SUBJECT: **R.E. Ginna Nuclear Power Plant**
Docket No. 50-244

**Response to Request for Additional Information Re: Fourth Interval
Inservice Inspection Program Relief Requests Nos. ISI-02 and ISI-03**

Utility: Constellation Site: Ginna Unit: 1 System / Weld ID: 'B' Steam Generator / NSE-3R

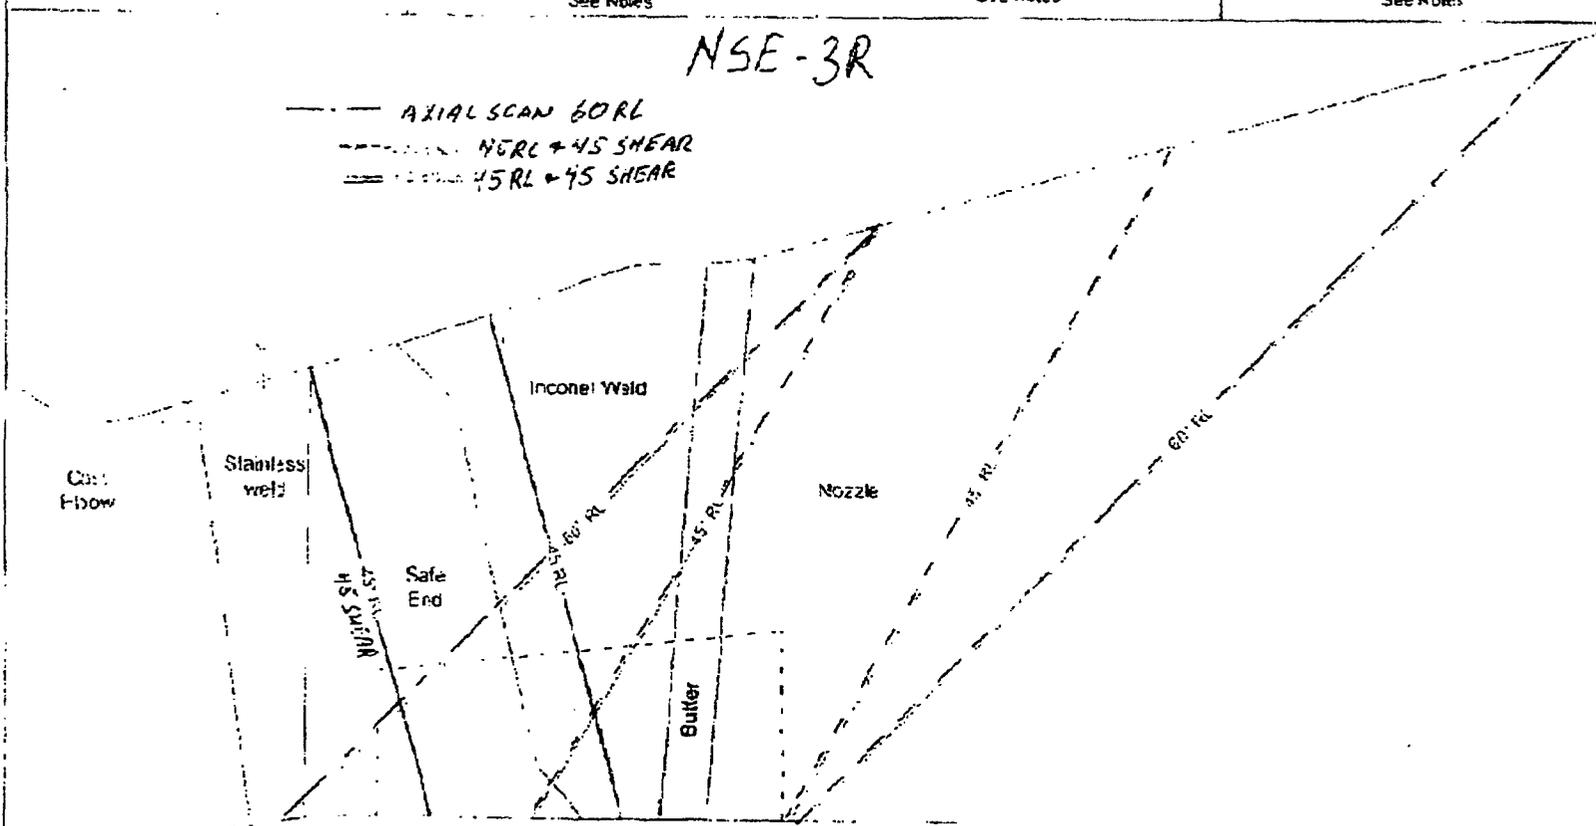
- b. *Please provide a figure and coverage calculations for Component ID NSE-4R (I007190) and coverage calculations for Component ID NSE-3R (I006990). Please ensure that figures provided for both components clearly depict all wave modalities and insonification angles used (please note that the figure and caption should match) and examination limitations encountered. Please keep in mind that the figures are transmitted as black and white, so that different styles of lines should be used to distinguish between axial and circ scans or, if necessary, provide a figure for each of the scan directions.*

- c. *It is the NRC staff's understanding that the Performance Demonstration Initiative (PDI) program requires two angles in order to claim ASME Code coverage for a Supplement 10, single side exam. Please clarify whether your Code coverage calculations were made using two angles. Did a single angle provide greater coverage? If so, how much?*

For component NSE 3R and NSE 4R, the 45 degree Refracted Longitudinal (RL) wave axial transducer obtained 2.34 Square Inches of the code required area of 4.51 Square Inches from a single direction. Resulting in 52% coverage of the code required area (volume). The limitation was caused by component geometry.

For the 60 degree (RL) wave examination of NSE 3R and NSE 4R, 4.32 square inches of coverage was obtained of the 4.51 square inches of code required area (volume). Resulting in 96% coverage. The limitation was caused by component geometry

The 45 degree circumferential examinations, which were conducted from the safe end side of the weld, were limited by part geometry and surface condition. For NSE 3R 2.62 square inches or 58% of the code required area (volume) was scanned. This number was reduced 50% by the examiner due to the surface condition of the component and an inability to maintain adequate contact during the examination. For NSE 4R 2.88 square inches or 64% of the code required area (volume) was scanned. This number was reduced 45% by the examiner due to the surface condition of the component and an inability to maintain adequate contact during the examination. As indicated on the ultrasonic coverage and limitation sheet.

The percentage calculation for NSE 3R would be 52% for the 45 RL, 52% for the 60 RL 29% for the circumferential clockwise examination and 29% for the circumferential Counter clockwise examination. This results in a coverage of 40.5%

Notes: Coverage information given is the best estimation due to component geometry. Achieved coverage of the circumferential examinations, as illustrated, was reduced by 50% due to loss of contact and restricted ability to perform skewed scans as required by Technical Justification IR-2009-381, as a result of surface condition. Above illustration not to scale.

Attachment 2a
Examination Coverage for RC-PL-FW-XV

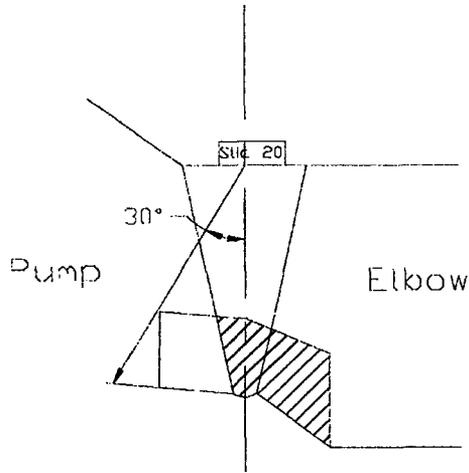
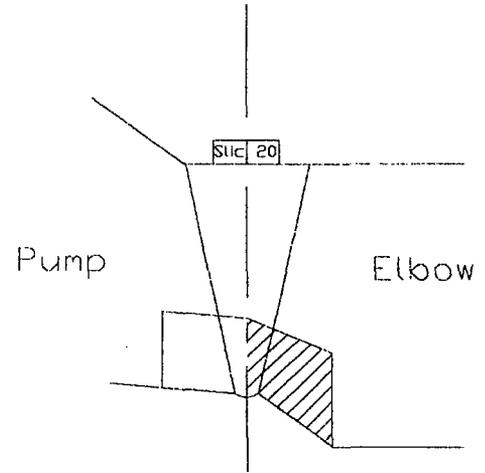
- b. *For Component ID PL-FW-XV (I013500), the use of insonification angles of 20°L/30°L is atypical. Was the procedure qualified to the PDI? Were these angles used for both the axial and circumferential scans? Why weren't any shear wave exams performed? Lastly, the sketch of this component for the axial exams indicates that there was coverage on the pump side, even though the pump is cast. Please provide clarification.*

- b. This ISI weld (PL-FW-XV) configuration is a Cast Stainless Steel elbow to Cast Stainless Steel pump casing, therefore the procedure used was not qualified to PDI. The procedure used manual ultrasonic with best available technology, where grain structure contributes to considerable sound attenuation and diffusion. The ISI vendor provided a search unit (SLIC20) to the site that produced a better signal to noise response than the 45° shear wave used previously (1995). The ISI vendor demonstrated on the site's CSS calibration block that the 20°L/30°L search unit could see the ID notch at the component thickness (2.4") as compared to the shear wave. Based on these facts, the weld was examined with these transducer angles. Coverage plot and transducer focus plot information are provided in Attachment 2a and 2b.
